SB AC32/04

TITLE:	Hardware Version 2.20 to 2.21 – Resistor Change on ARINC Module			
DOCUMENT NUMBER:	SB AC32/04			
EQUIPMENT:	AC32 Digital Air Data Computer			
© Copyright by THOMMEN AIRCRAFT EQUIPMENT AG, CH-4132 Muttenz, Switzerland

SERVICE BULLETIN

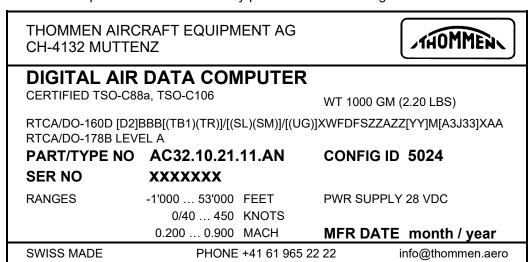
The MOD column will identify the modification status MOD01A and HW version 2.21.

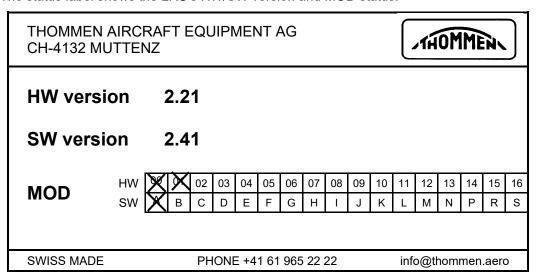
The status label shows the LRU's HW/SW version and MOD status:
